LETTER TO THE EDITOR:

Re. Paper by Dhakal, Khare and Mander “Economic Payback of Improved Detailing for Concrete Buildings with Precast Hollow-Core Floors” in NZSEE Bulletin Volume 39, No 2, June 2006, pp106-119.

AUTHOR’S RESPONSE: Rajesh P Dhakal and John B Mander

Figure 8. Fragility curves for a DS3 and DS4 boundary (interpreted as $\mu = 4$).

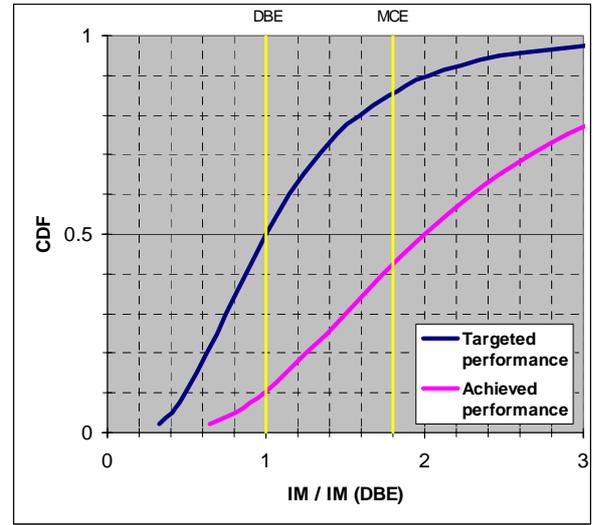
- *The tool, with further refinement, may prove to be useful; however, the conclusions and assumptions used in the article appear very questionable. For example the results indicate (Figure 4d) that approximately 30% of modern structures will survive a 2500 year seismic event with no damage and 40% will only sustain slight damage. Given that most structures are designed to exhibit inelastic action in a 500 year return period seismic event, the estimate performance of “modern structures” appears dramatically over stated.*
- ➔ The authors agree that there is room for refinement. Indeed, research is presently continuing at the University of Canterbury and elsewhere on investigating the seismic response effects on death, damage and downtime – all of which can be expressed in terms of dollars. However, we stand by our present estimates of damage as being indicative of response

and damage outcomes to the structures that possess traits similar to the systems studied [6-8]. Note that the tested structure with improved detailing was in damage state 2 (slight damage category) until 2% inter-storey drift; obviously this structure is unlikely to experience displacement ductility of 4 (what the modern capacity design aims for) in a design basis earthquake (DBE). In designing a structure, we strive to exceed a dependable target performance, and there is inherent conservatism in this process which we shall discuss below. We shall restrict our discussion to an exact match of the minimum standard expected of the NZ building code. Naturally, a designer is at liberty to exceed minimum standards provided that the principles of capacity design and protection are adhered to. In brief, even if design parameters are assigned values very close to the minimum required by design standards, there will be inherent overstrength in all designed structures. This is due to the use of characteristic (95th percentile) strength instead of the probable (50th percentile) strength. Also, strain hardening and dynamic (rate) effects add to the provided overstrength. This ensures most as-built structures perform significantly better than the milestone aimed in the basic design calculations.

To help explain this general outcome, consider the following simple example. Suppose we chose to design a structure on its probable material strengths for a DBE, rather than the customary specified strengths. Also suppose we could exactly match the required design quantity of reinforcing steel then the expected strength capacity of the principal beam members would be

Additional strength also arises from dynamic loading rate effects (15%) and redundancy (15%). In total, the expected (50th percentile) strength is in excess of a factor of two times higher than the code-based design capacity. However, for simplicity let us restrict the total dynamic overstrength to, say 2.0.

Now if we design a structure for an overall structure ductility factor of $\mu = 4$ we can assume that this is at the interface between damage state 3 and 4 – that is, the end of *repairable damage* and the onset of *irreparable damage*. For the case of the design based on probable (50th percentile or median) material strength we can expect that there is a 50 percent chance of achieving this for a DBE. Due to the aleotric uncertainties associated with the ground motion variability and randomness in material strengths, a fragility curve similar to the leftmost curve shown in Figure 8 results. In addition to there being a 50 percent chance of exceeding this performance limits for DBE (10% in 50 years) there is an 85% chance that this damage state has been exceeded for a maximum considered event (MCE), having 2% probability of occurrence in 50 years. Figure 8 also plots, in the rightmost curve, the fragility function based on the probable achieved performance. For a realistic structure designed to the specified properties with 100% inherent overstrength, the probability of reaching the design limits reduces from 50% to 10% for the DBE. Similarly, there is a reduction from 85% to 42% for the level of MCE when the design conforms to realistic mechanical properties.

It is thus evident that structures should perform better than intended by design. It is for this reason that fewer structures are damaged in earthquakes than that might be expected by design. Take for example the 1994 Northridge earthquake. Many regions of the greater Los Angeles region experienced ground motion in excess of the DBE motion (PGA = 0.4g). In fact PGAs

of 0.8g were not uncommon. And yet only a modest number of structures sustained irreparable damage or collapse; many of these failures were attributed to detailing or construction flaws. In fact, the observed damage is consistent with the rightmost fragility curve presented in Figure 8.
